ADDENDUM #4: November 15, 2019

FROM: Allied Engineering, Inc.
160 Veranda Street
Portland, Maine 04103
Telephone: (207) 221-2260

RE: Addendum No. **Four (4)** to the Bidding Documents for:
NEW MECHANICS GARAGE LITCHFIELD MAINTENANCE FACILITY MILE
MARKER 92.7

CONTRACT 2019.12, NEW MECHANICS GARAGE
LITCHFIELD MAINTENANCE YARD, MILE MARKER 92.7
STRUCTURAL - FOUNDATION PLAN
ADDENDUM 4 - NOVEMBER 15, 2019
SHEET NUMBER: SB-100
CONTRACT: 2019.12
24 OF 41

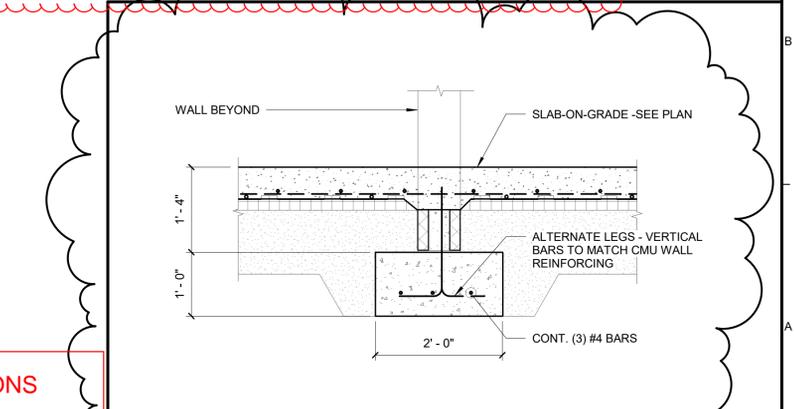
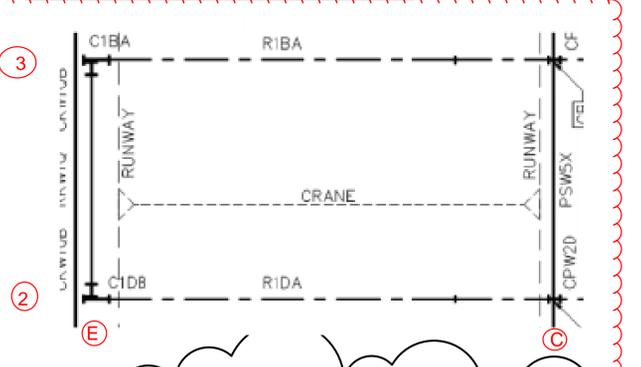
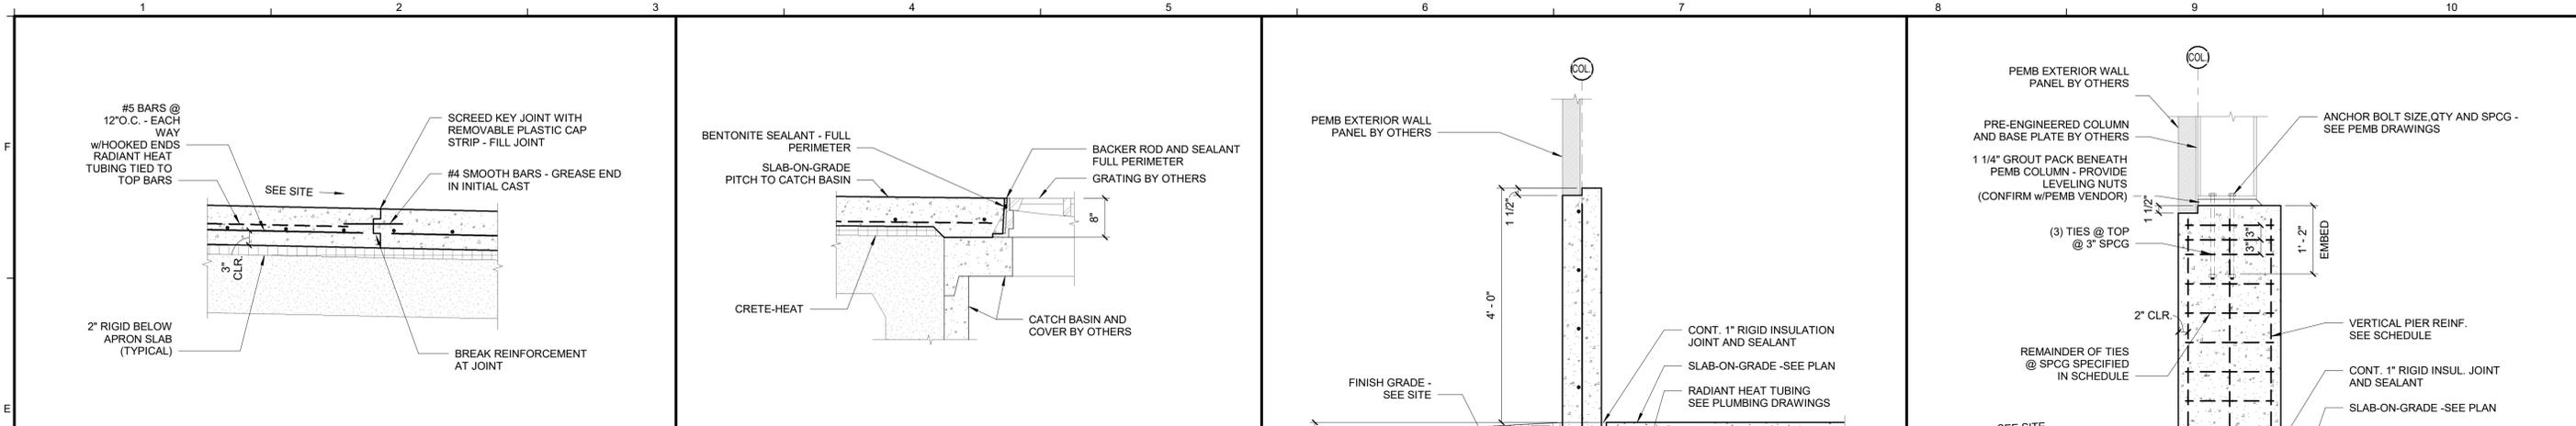
3. DRAWING SB-100 STRUCUTRAL - FOUNDATION PLAN: **DELETE** in its entirety and **ADD** in its place the revised sheet attached to this addendum. Drawing SB-100 has been updated to incorporate masonry wall and footing changes
4. DRAWING SB-100 STRUCUTRAL - FOUNDATION PLAN: Hand markup of potential portal and rod bracing opportunity locations.

4				SB-100 has a note that reads: "Dimensional layout/foundations/pier sizes are preliminary. Final dimensions/foundations/pier sizes shall be determined upon receipt and approval of final pre-engineered metal building (PEMB) shop drawing submittal package including member sizes and reactions". Please confirm that pricing is to be based upon the SB-100 foundation plan and that any required modifications or changes that result in more/less cost will be handled via change order.	AEI: Should changes result to the foundations from PEMB design load calculations, then yes, a change order for foundation changes at pier locations may result."
5				Drawing EP-100, 38 of 40, depicts duplex cord reel outlets overhead of the work bays. Please confirm if only a duplex receptacle is desired, or if a cord reels is also intended to be furnished and installed. If a cord reel is required, please provide a specification.	AEI Cord reel was added to spec in addenda 1

SHEET NUMBER: SB-500

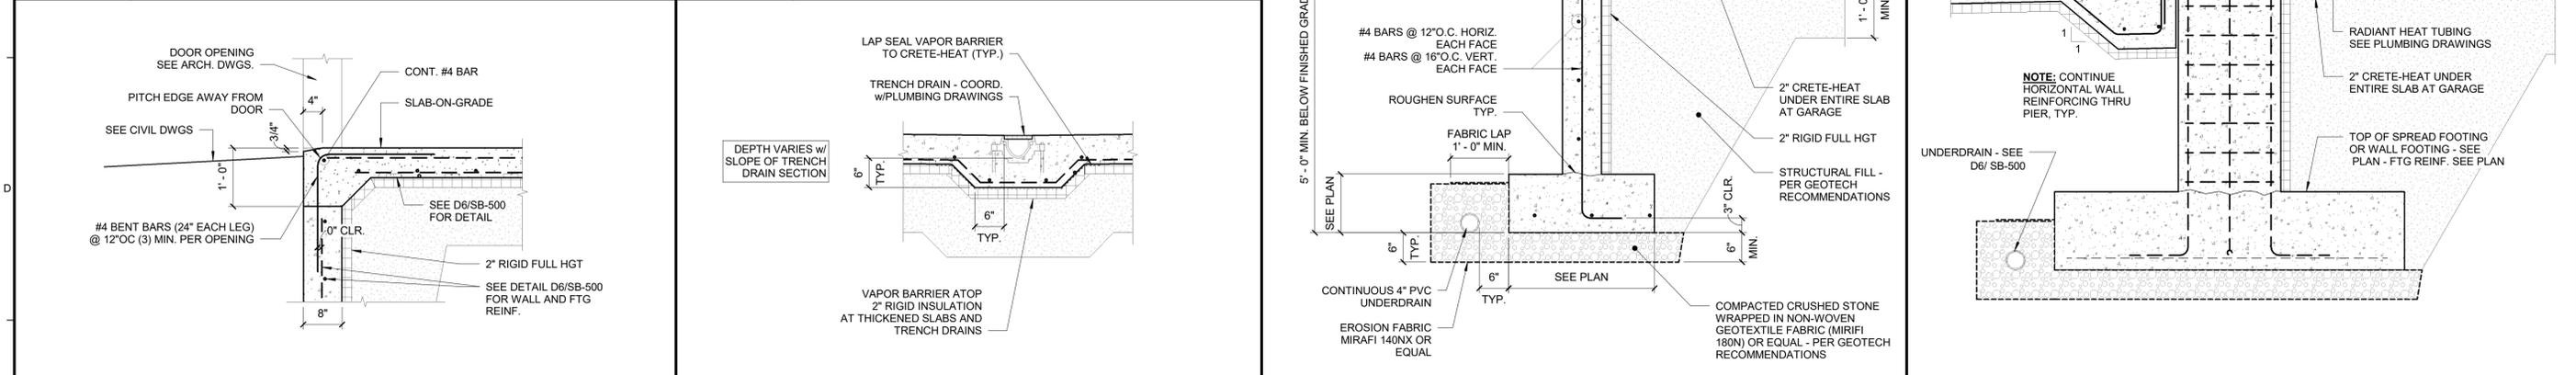
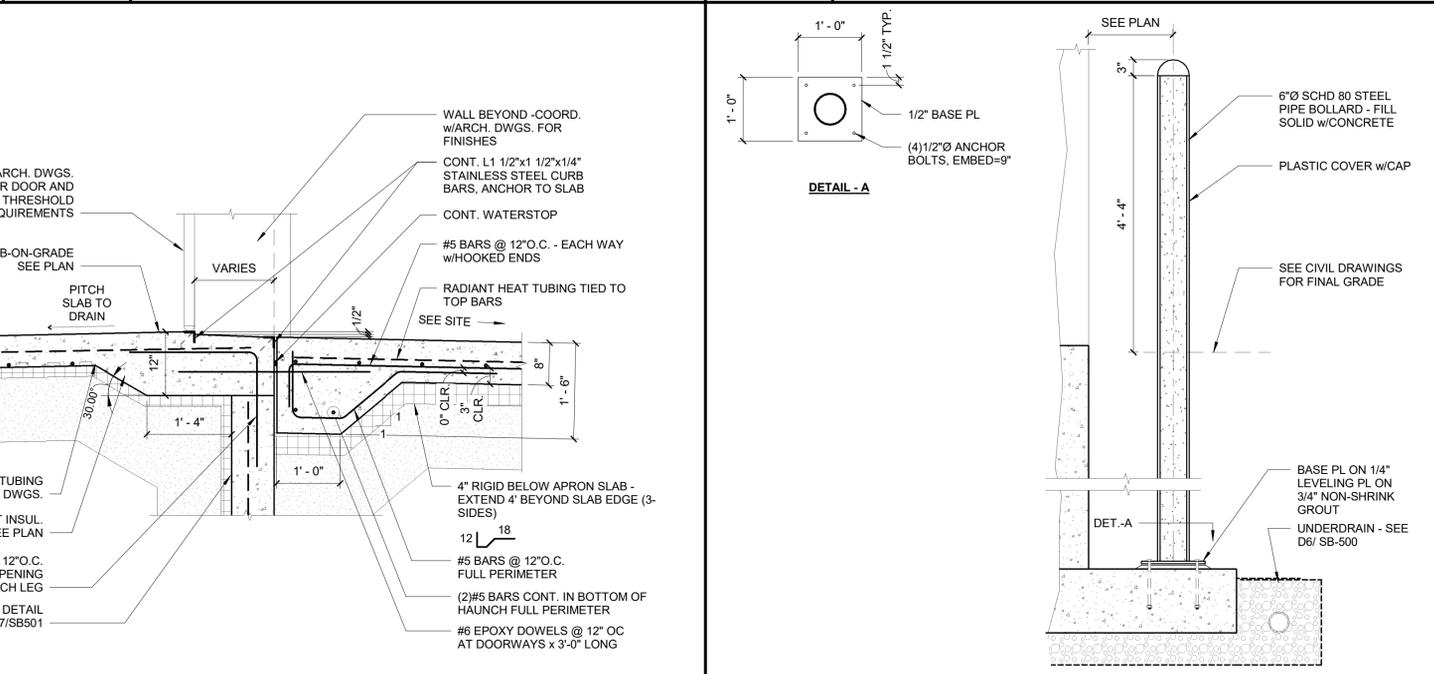
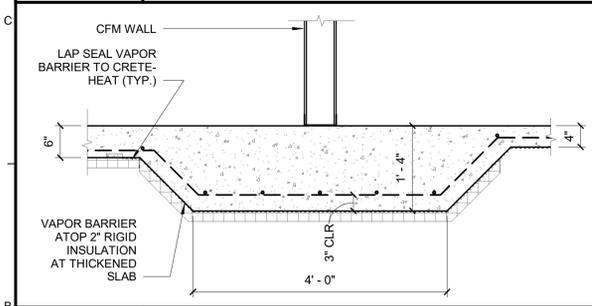
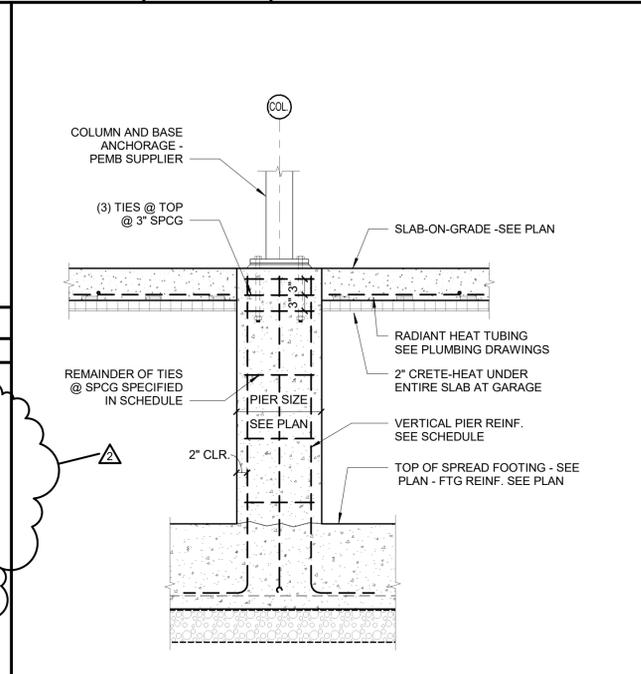
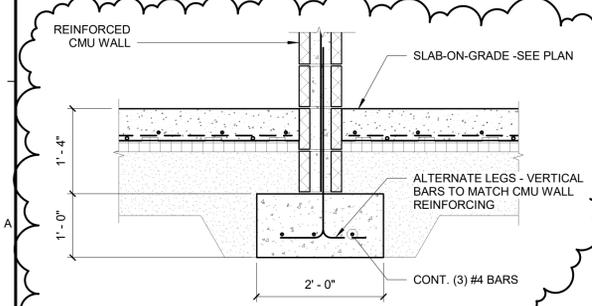
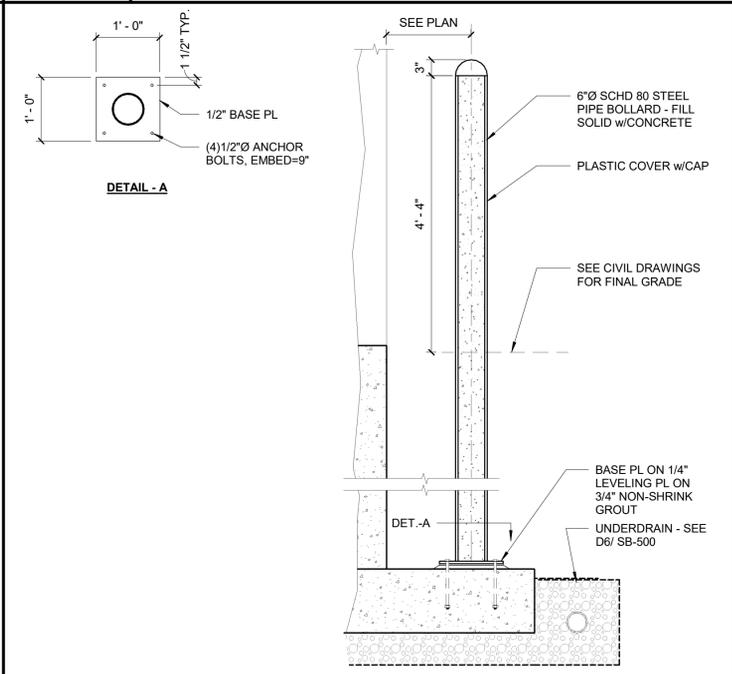
5. DRAWING SB-500 STRUCUTRAL - FOUNDATION DETAILS: **DELETE** in its entirety and **ADD** in its place the revised sheet attached to this addendum. Drawing SB-500 has been updated to incorporate masonry wall and footing changes

SHEET NUMBER: SF-500

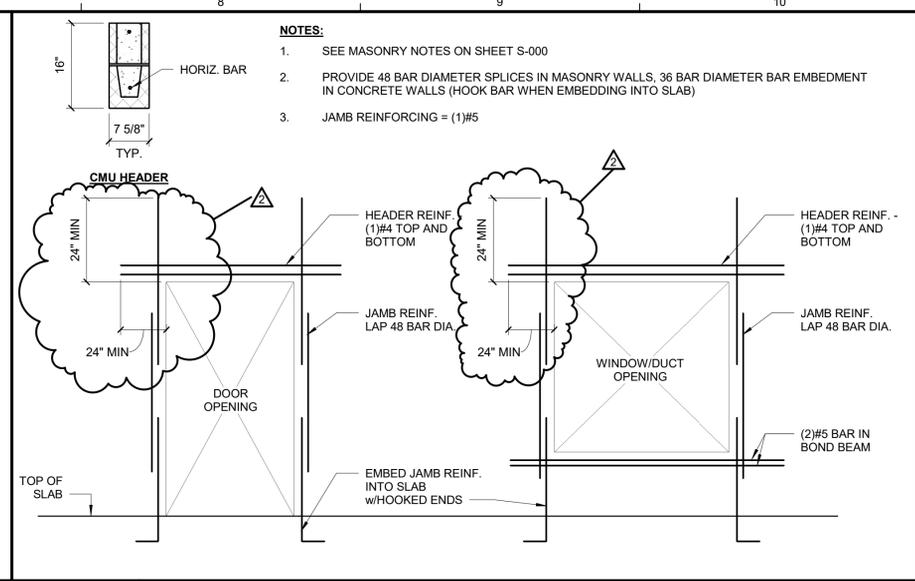
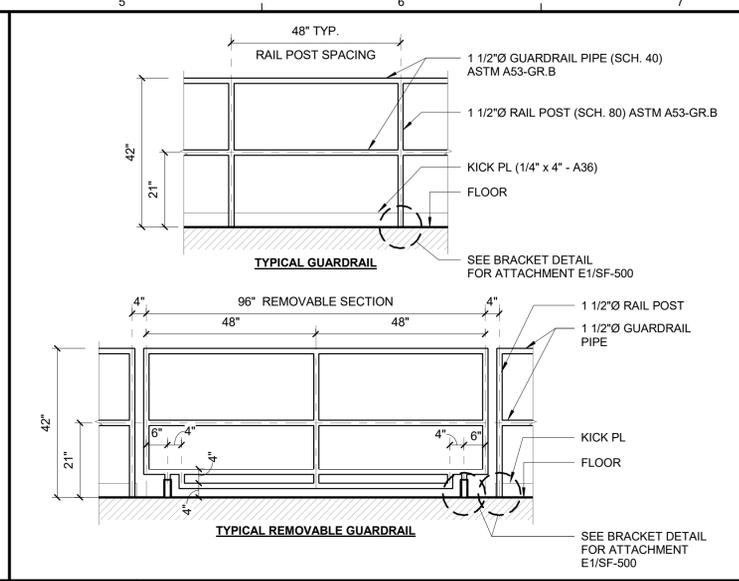
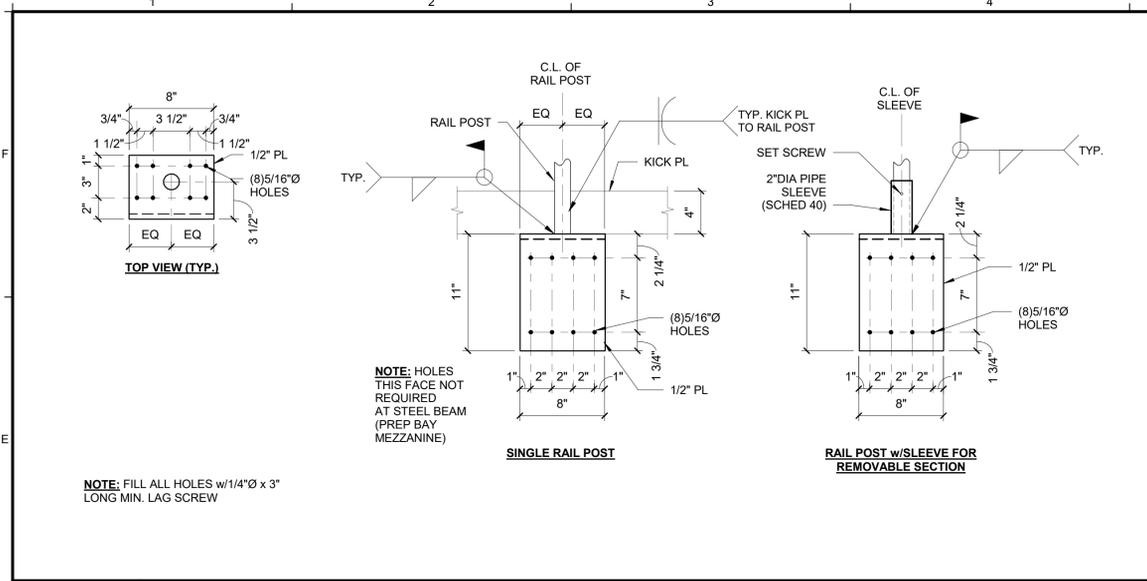
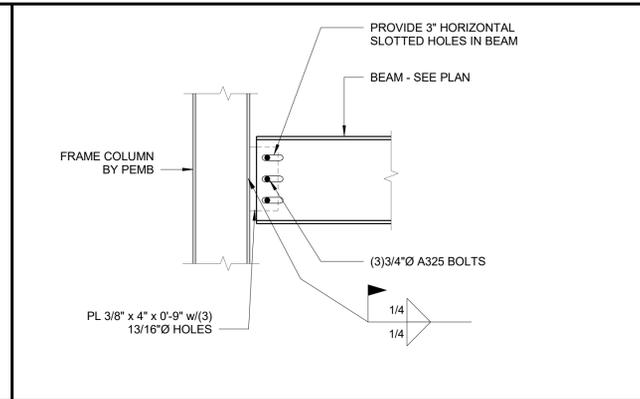
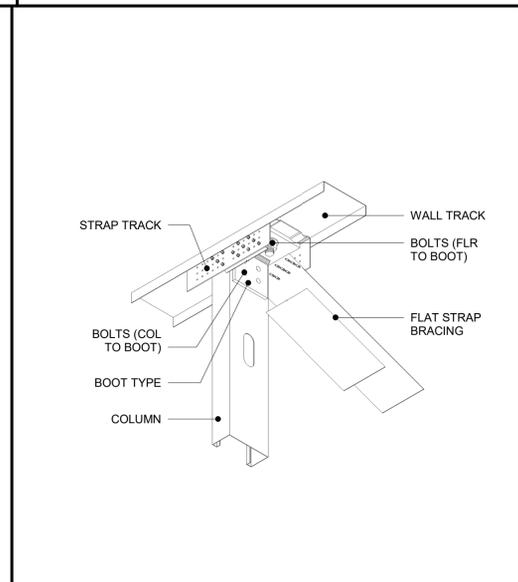
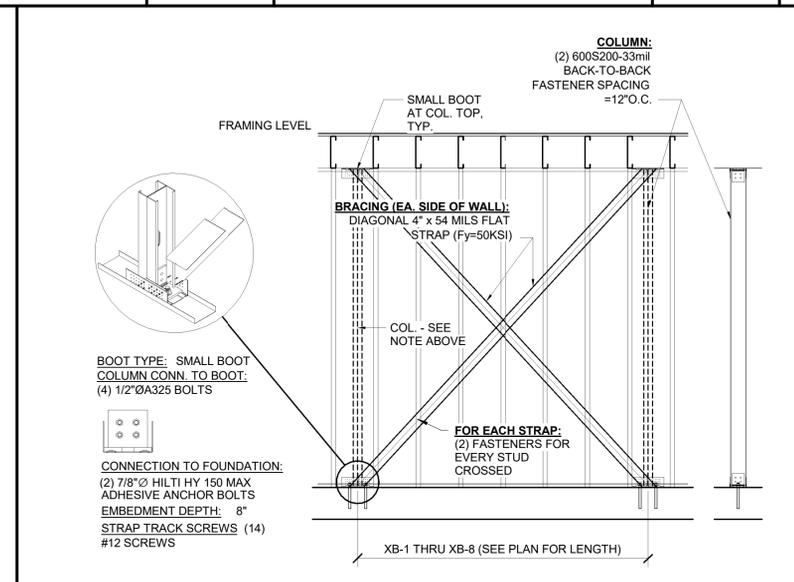
6. DRAWING SF-500 STRUCUTRAL - DETAILS: **DELETE** in its entirety and **ADD** in its place the revised sheet attached to this addendum. Drawing SF-500 has been updated to incorporate masonry wall changes

SHEET NUMBER: EP-100
CONTRACT: 2019.12
38 OF 41

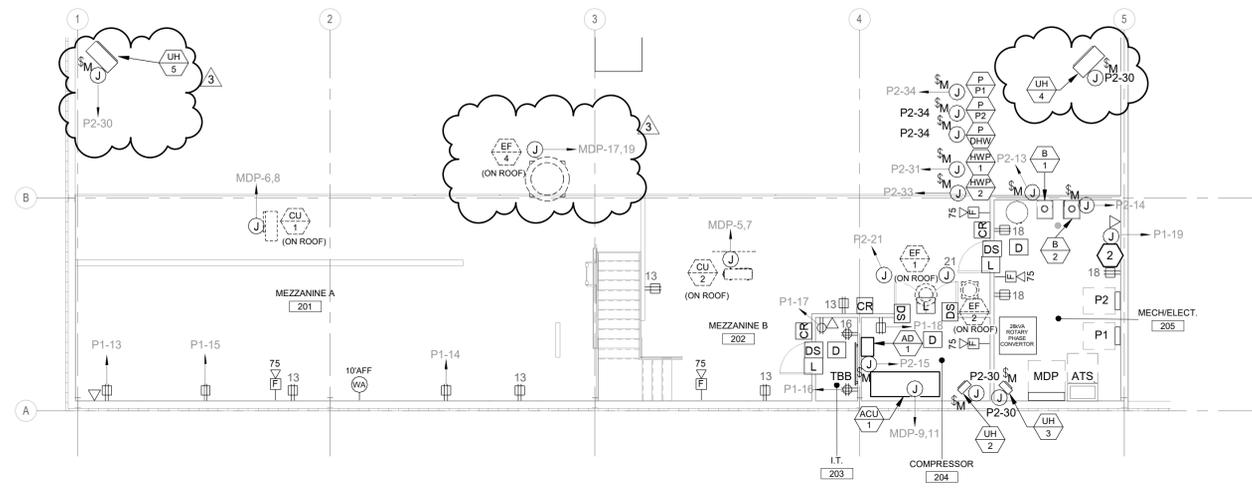
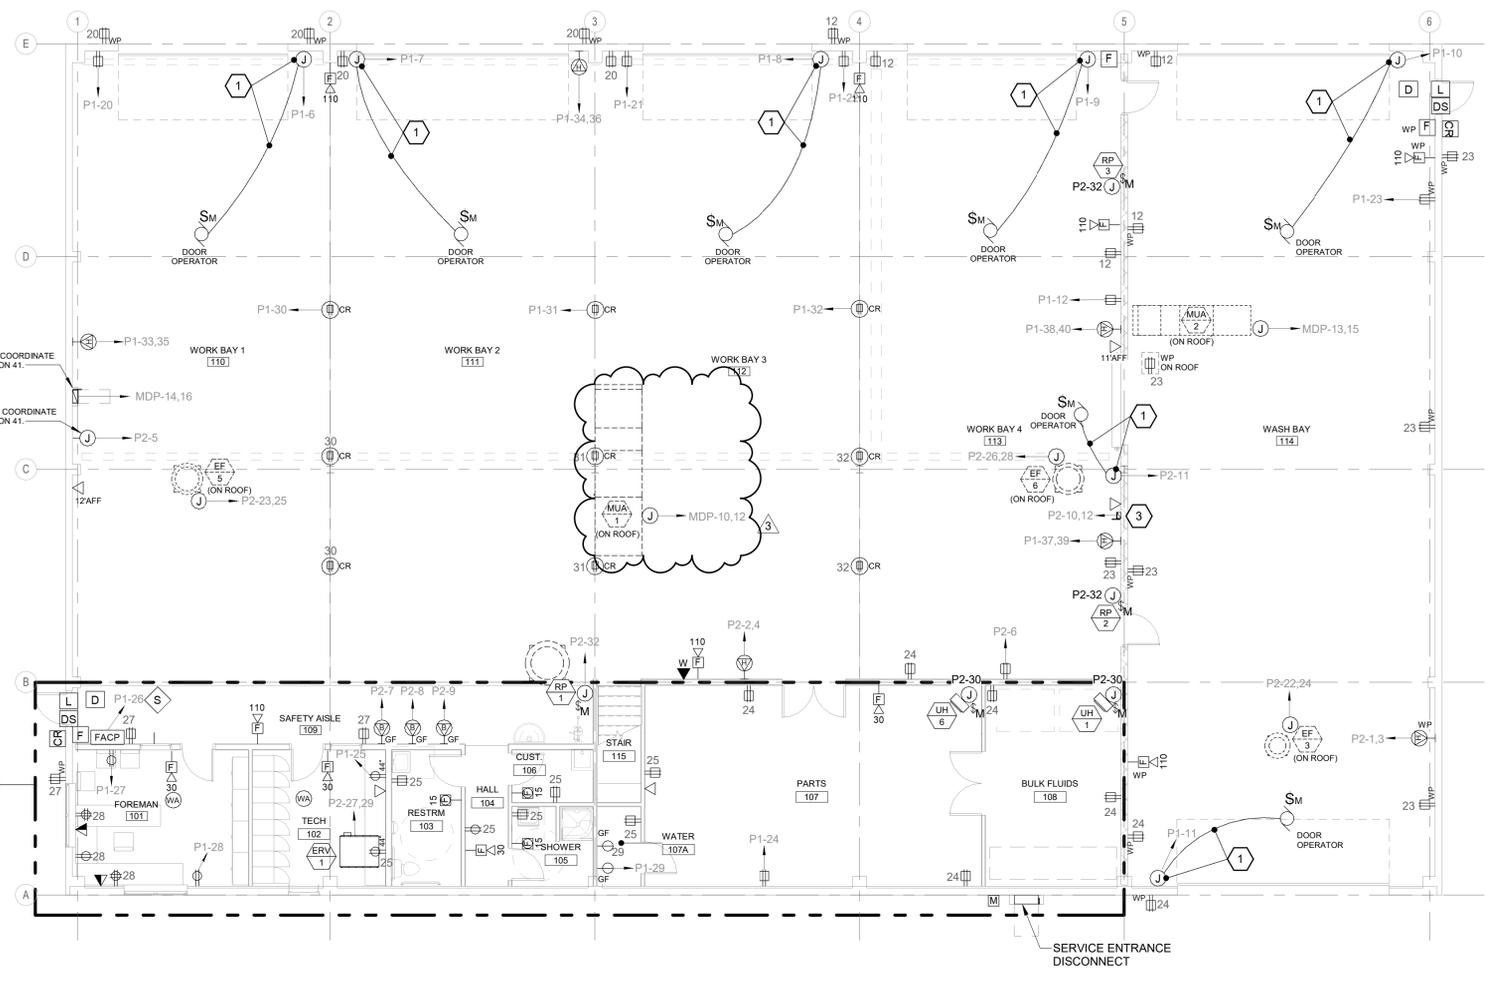
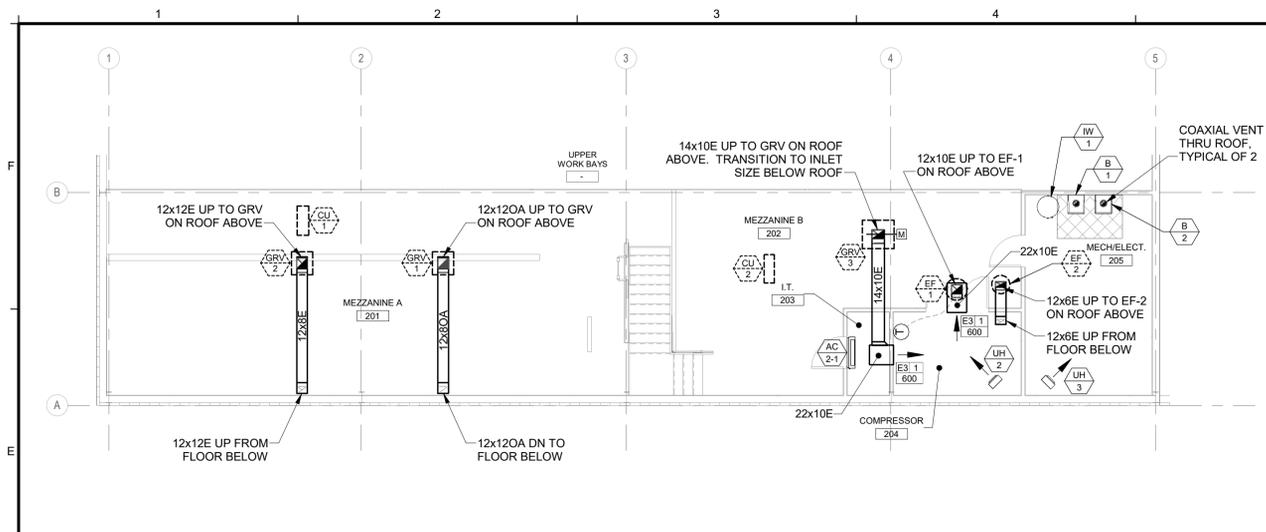
7. DRAWING EP-100 POWER AND SYSTEMS PLAN: **DELETE** in its entirety and **ADD** in its place the revised sheet attached to this addendum. Drawing EP-100 has been updated to incorporate mechanical equipment location changes.
